Comments on the Proposed Alternative: Mid-Channel Diversion

Department of Water Resources

Division of Planning and Local Assistance

Bypass Tunnel Closure:

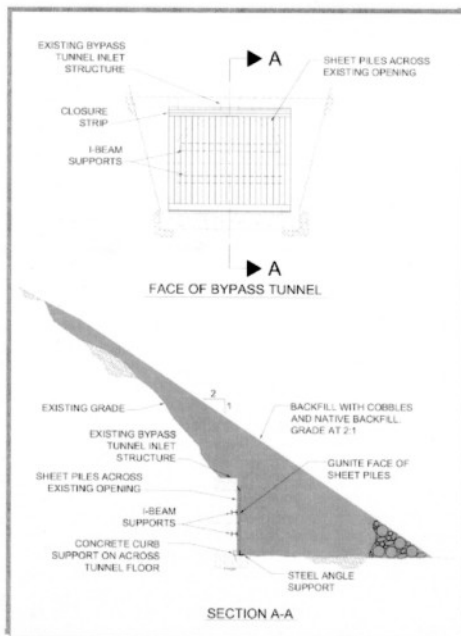
The Proposed Alternative is recommending the closure of the existing bypass tunnel "by placing sheet piles, sheet plates, reinforced concrete, and large rock across the face of both the inlet and outlet" (pg. 2-21) as illustrated by the adjacent graphic from the public workshop presentation.

As currently proposed, the bypass tunnel closure concept raises some potential concerns:

1. The stability and reliability of the 2:1 engineered fill slopes covering the closures during a 1% probability event (100-yr. storm).
2. The structural integrity of the sheet pile/sheet plate/reinforced concrete pipe closure under flood and soil loading. Most tunnel closures involve construction of a concrete plug at least two (2) times the length of the tunnel's diameter. The sheet pile/soil backfill closure does not appear to be a structurally positive plan.

3. The necessity of the engineered backfill cover over the bypass tunnel closure.
4. The piping failure of the backfill into the tunnel through the sheet pipe in a large event.
5. The eventual corrosion failure of the steel sheet piles and reinforcing members.

D. As described in the Draft EIS/EIR, page 2-21, the bypass tunnel closure design will allow for reopening the tunnel in the event that Auburn Dam is reauthorized. As part of the 1997 Value Planning Study, alternative ways for preventing boaters and swimmers from entering the tunnel, or being impinged on screens, were evaluated with and without restoring the river channel. It was concluded that there is no safe way of accomplishing this without directing the water around the tunnel. The Proposed Project represents a design that protects boaters and swimmers while providing a "temporary" closure of the tunnel. Filling the tunnel, or installing a concrete plug would accomplish the safety objectives, but would make it more difficult to reopen the tunnel at a later date, if needed.

The lead agencies recognize concerns regarding the permanency and specifications of the tunnel closure. The tunnel closure, as designed, entails placing sheet piles at the tunnel inlet and outlet. The sheet piles would be covered with shotcrete (Gunite) and covered with a stable engineered fill. This method of closing the existing tunnel will be permanent (i.e., will not require replacement) but would allow re-opening of the tunnel in the event that a diversion tunnel is needed in the future. Completely filling the existing tunnel with grout or earth would preclude future access (except via excavation), and would require approximately 84,000 cubic yards of material. Although the tunnel will not be filled in completely as designed, there would be no danger of caving in because the tunnel passes through rock and is lined with structural grade concrete.

Concerns over water permeating the engineered fill and sheet piles at the tunnel inlet or outlet have been noted. While water entering the tunnel is not likely to occur under current design specifications, the design could be augmented by using an impermeable membrane incorporated between two layers of Gunite, in place of the single layer of Gunite. A reinforced concrete wall could also be constructed against the sheet piles.
